ADDENDUM 1 (PENDING DSA APPROVAL)

PROJECT: **Santa Ana College**
 Science Center

DATE: 8/23/2017

DSA File No.: 30-C2
DSA Applications No.: 04-115788
HGA Commission No.: 3584-001-00

S8.14

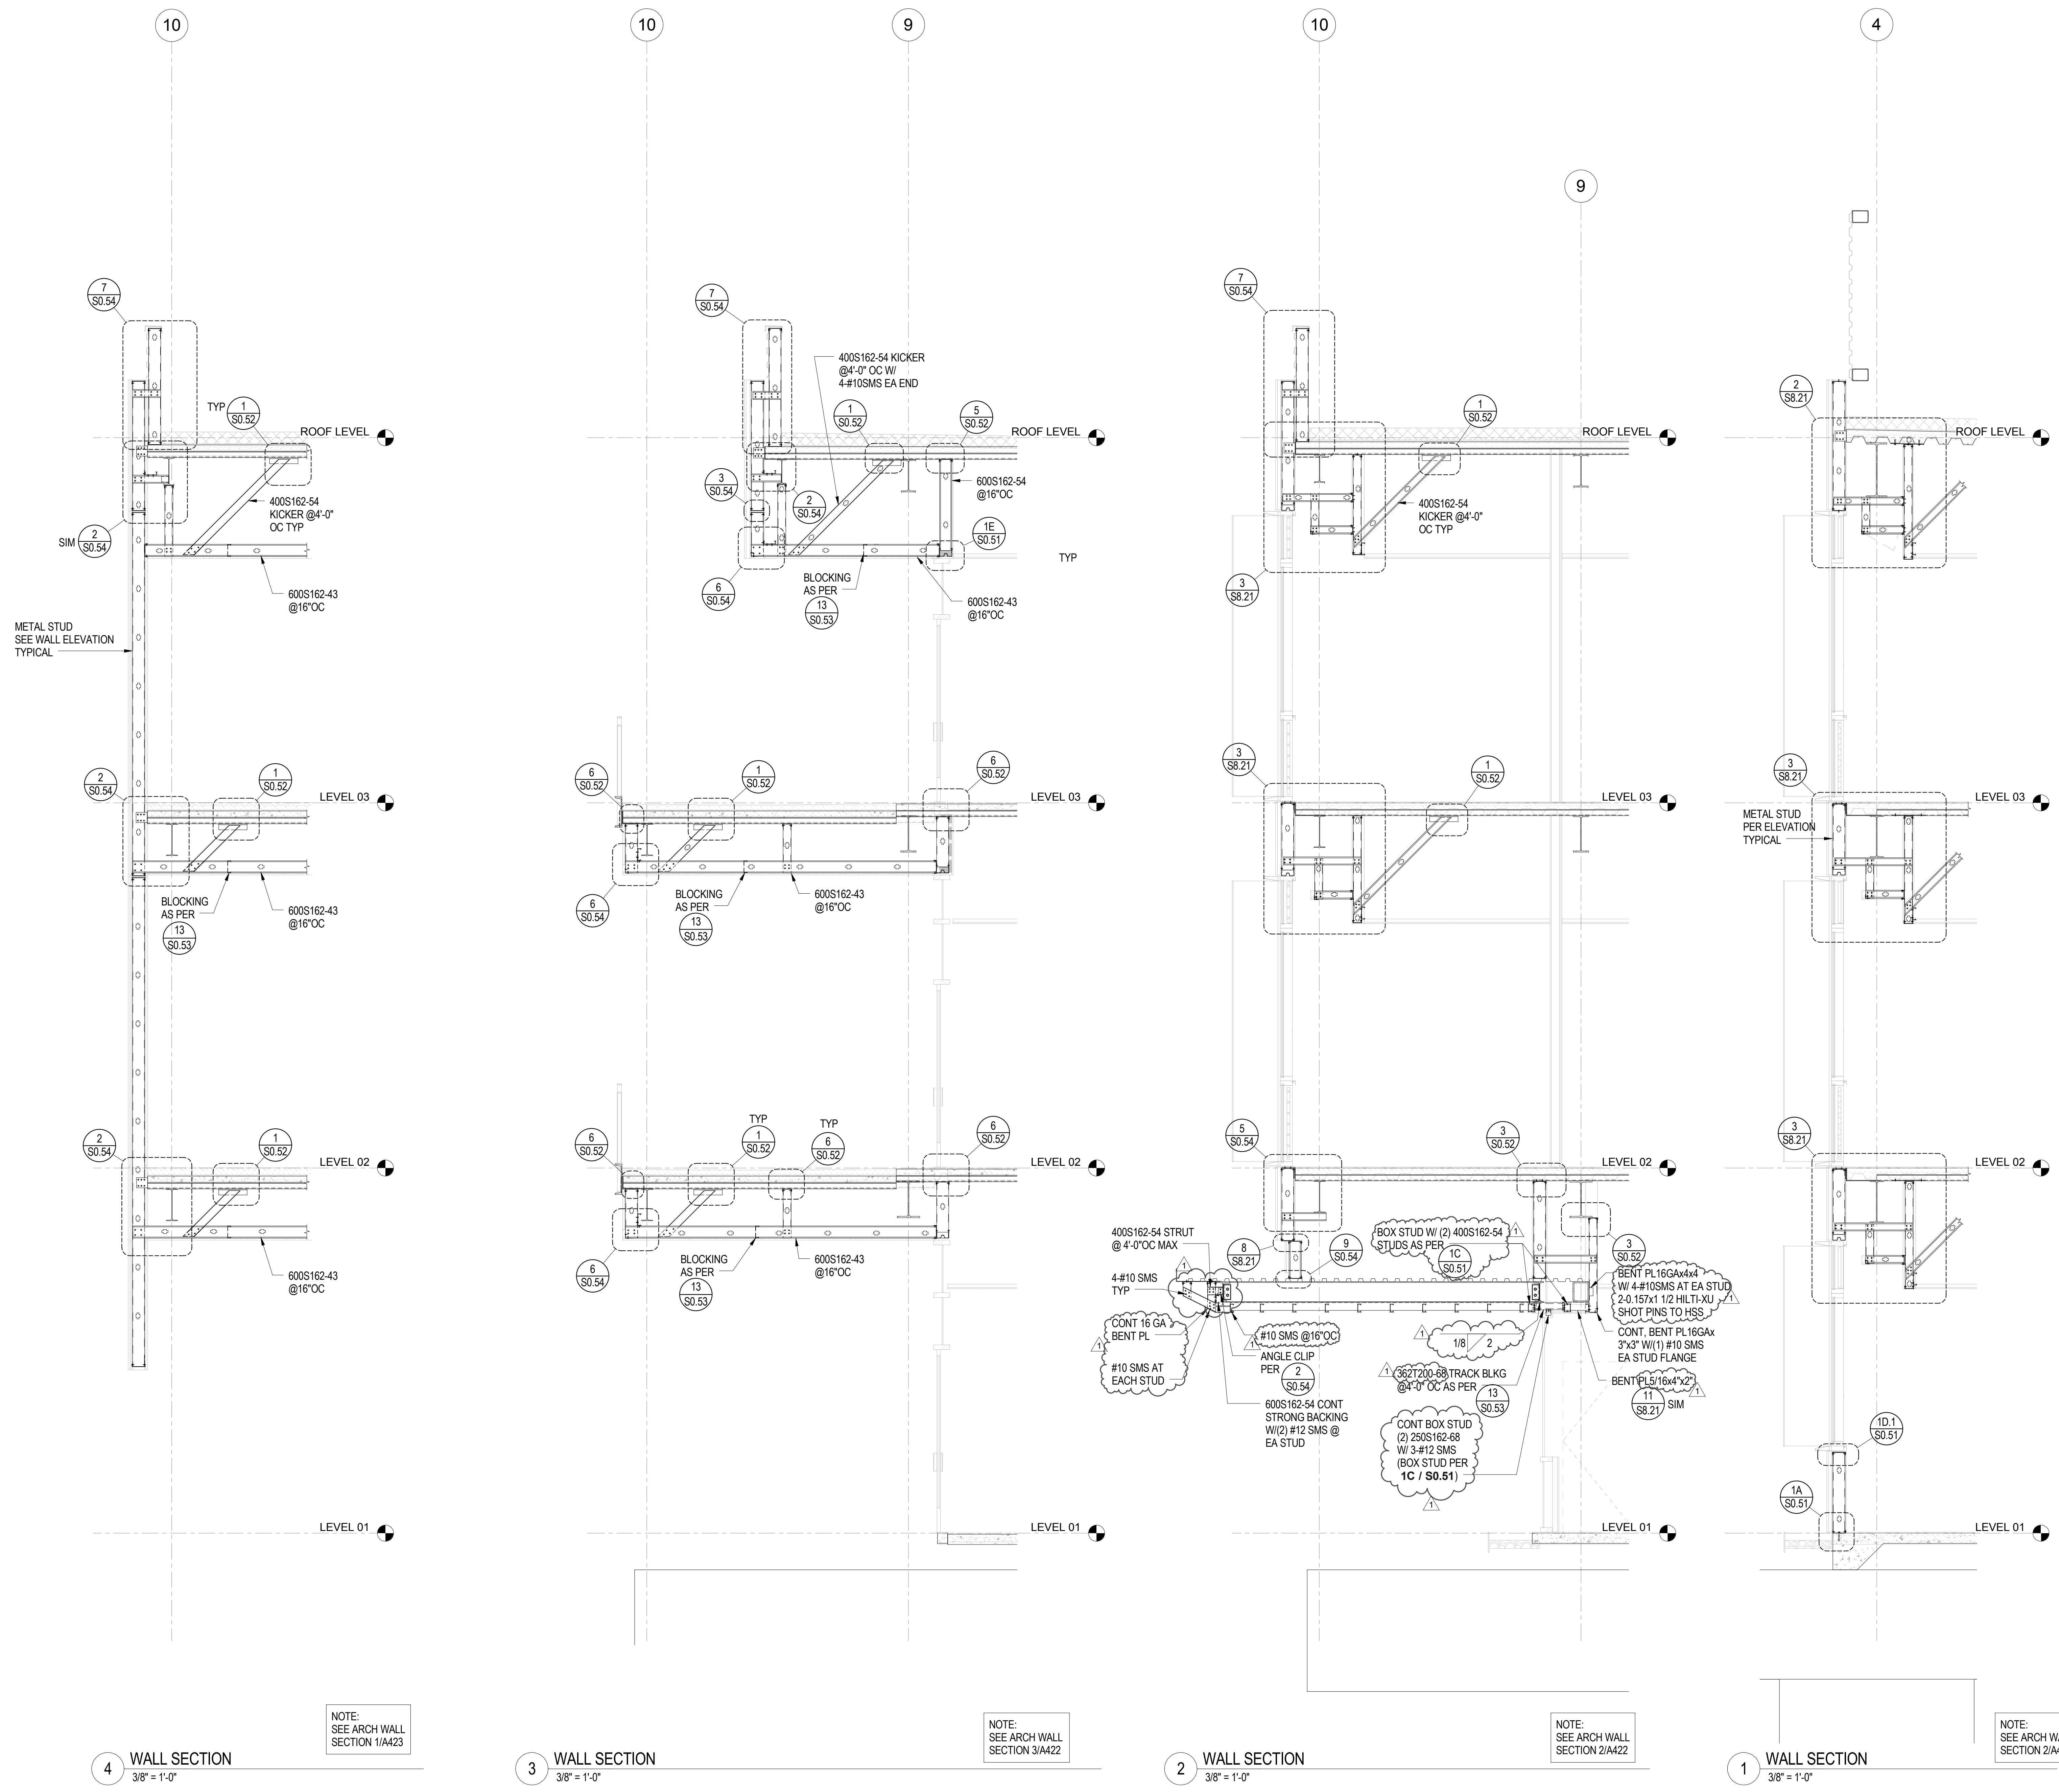
- Detail 2 has been updated based on the revised canopy extent. Additional clarifications provided.

**PLUMBING
UNDERGROUND
LEVEL PLAN**

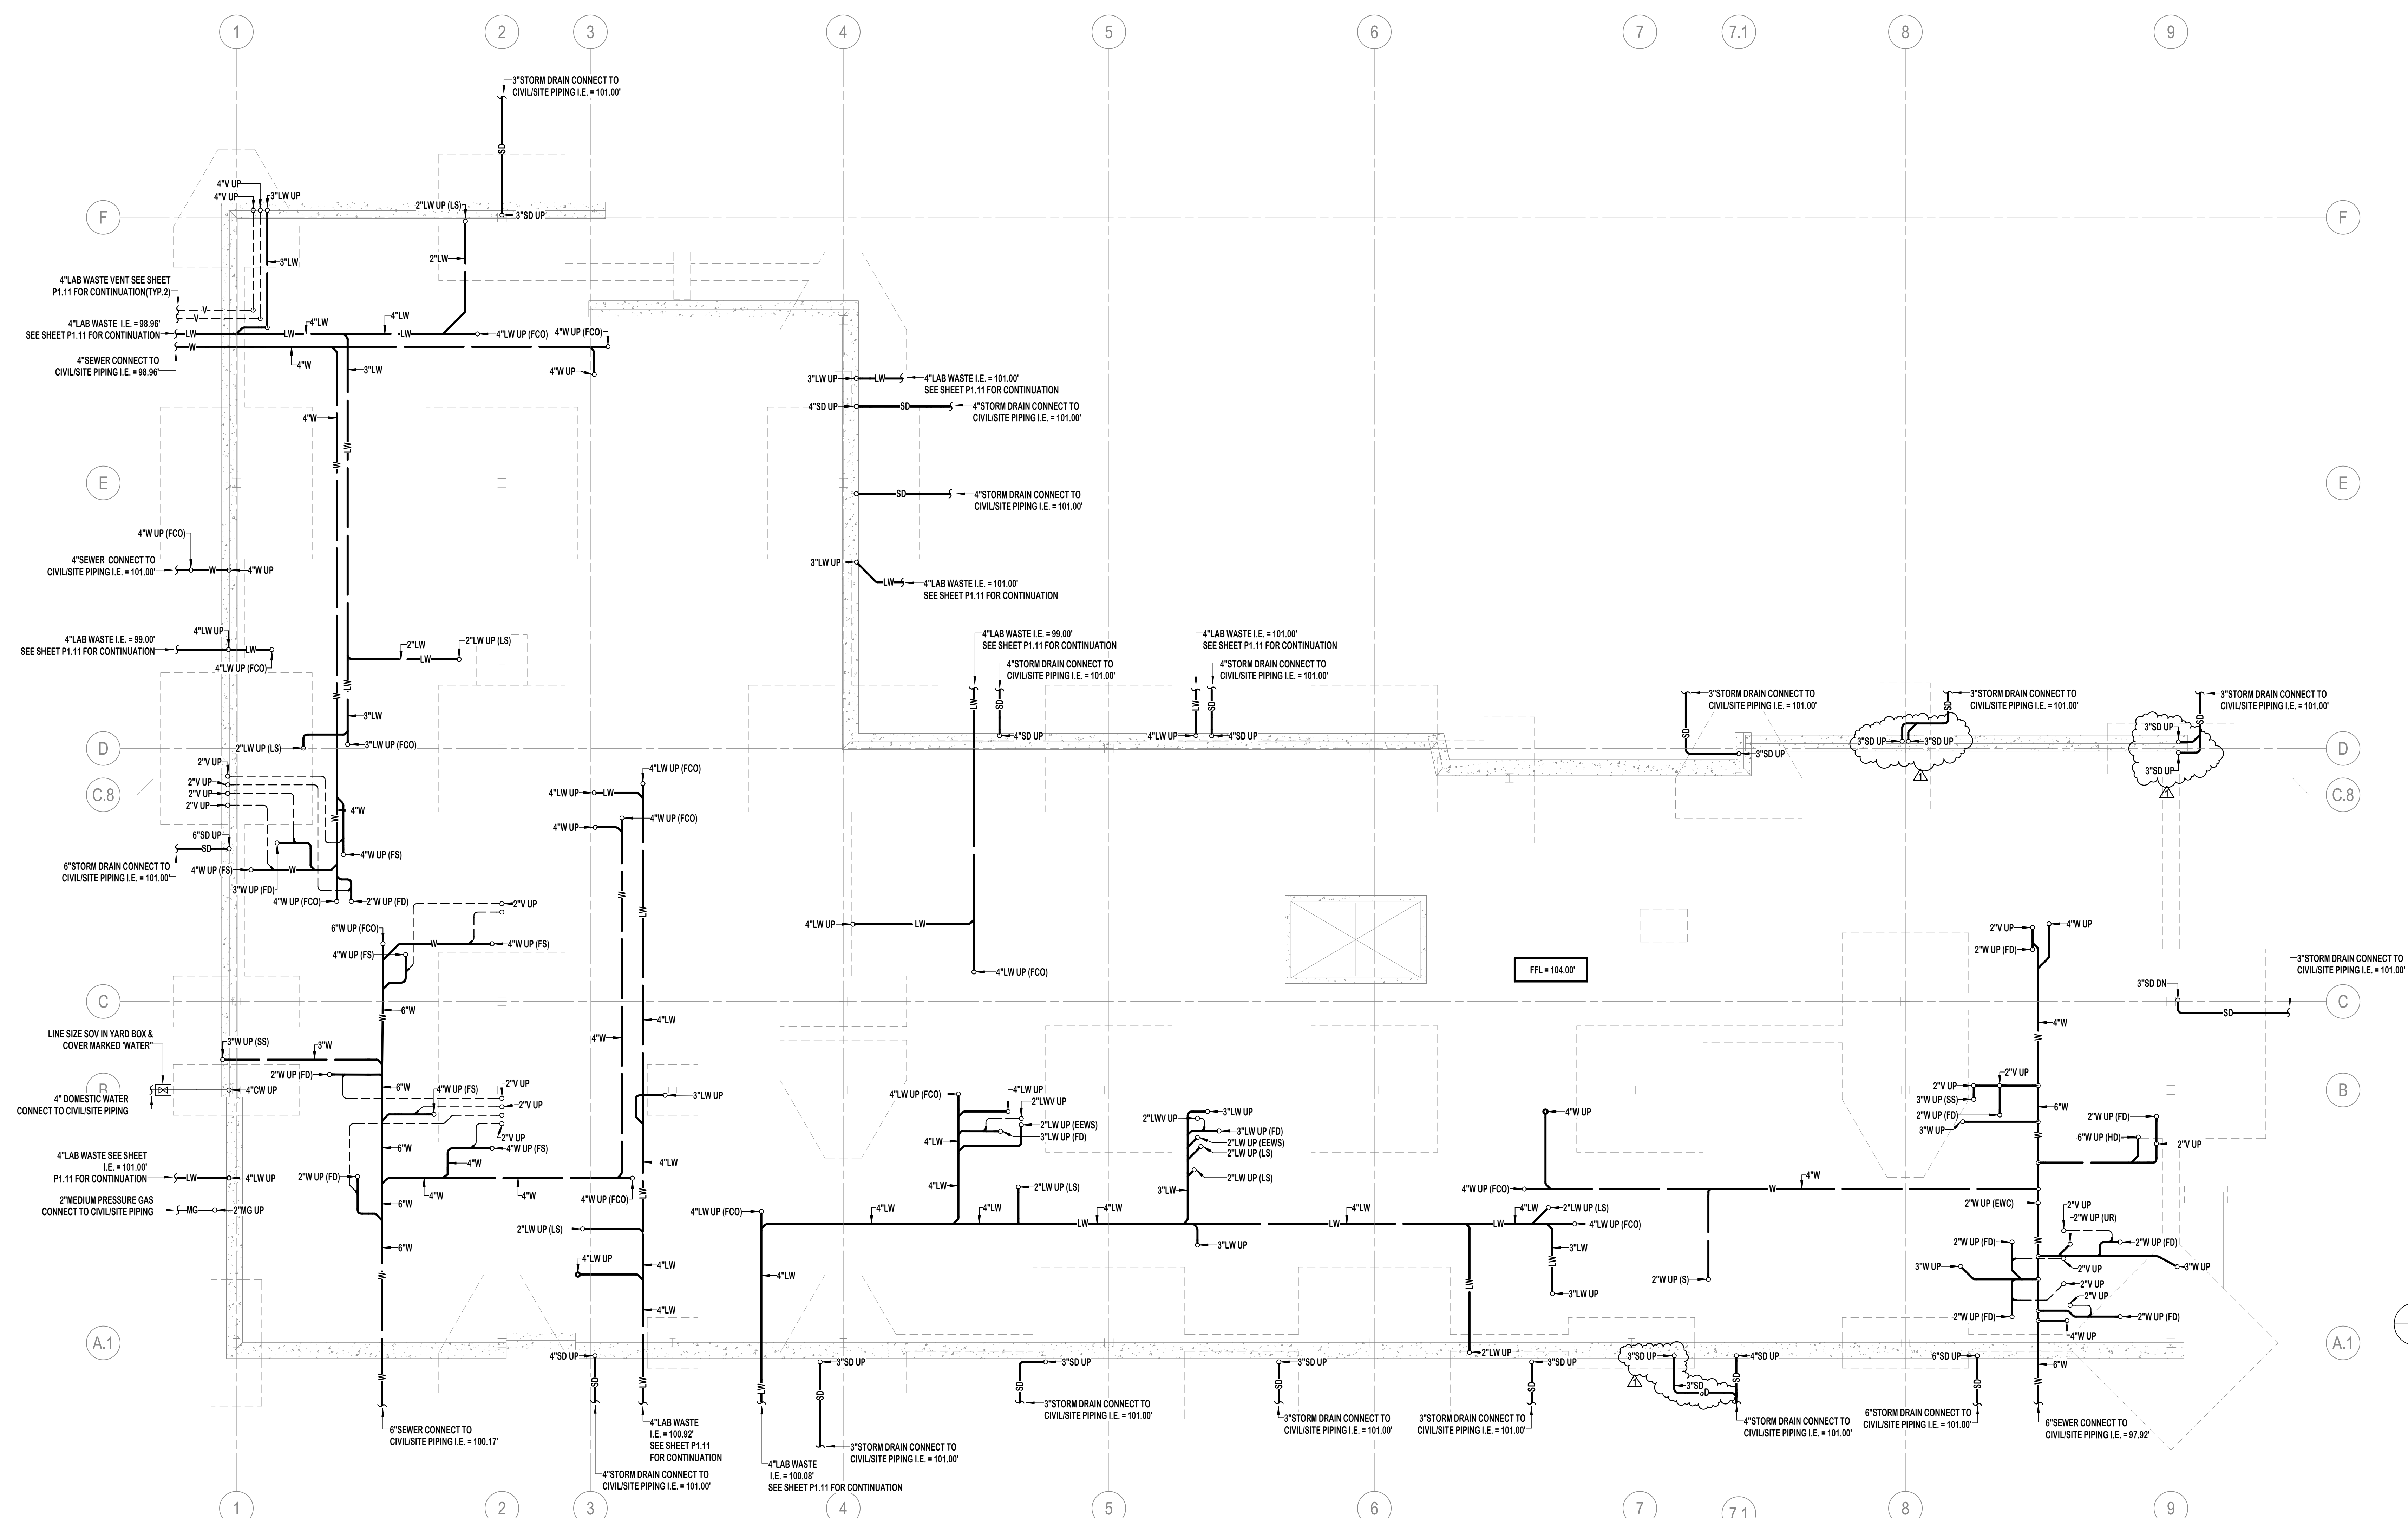
- North canopy reduced by 5'-0"
- Revised storm drain pipe layout

PLUMBING FIRST LEVEL PLAN

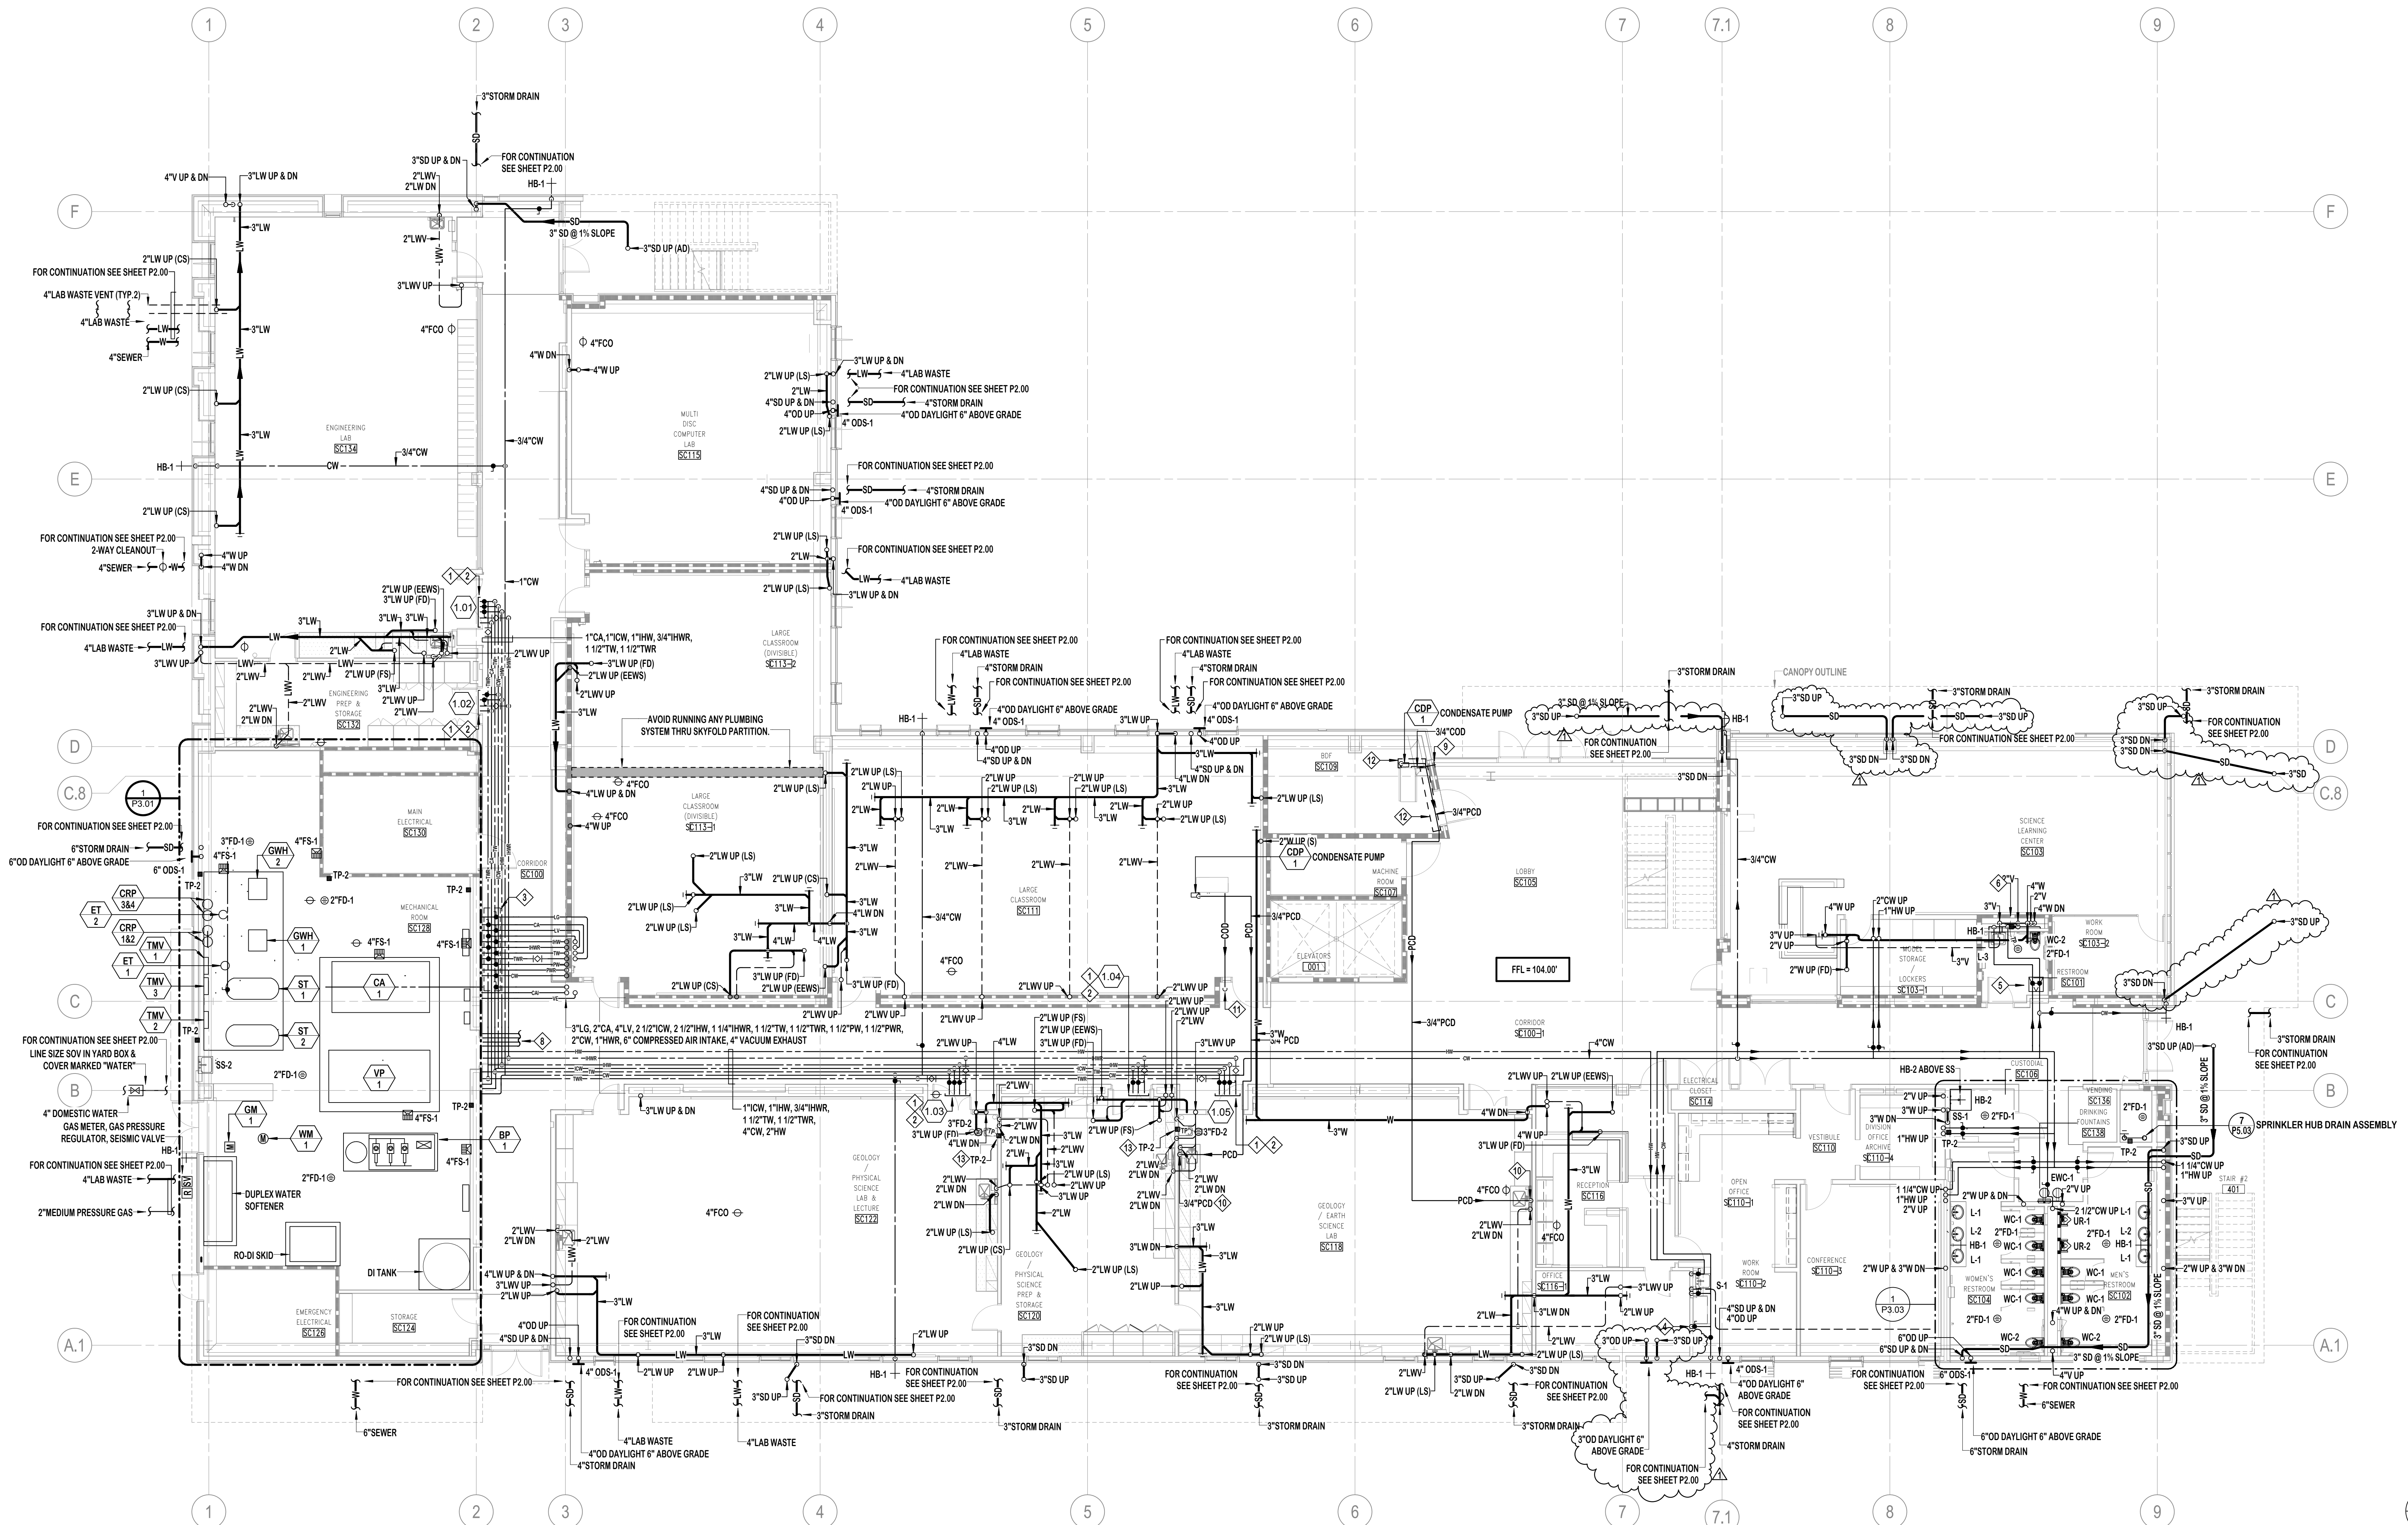
- North canopy reduced by 5'-0"
- Revised storm drain pipe layout
- Added storm and overflow drains in south side of building
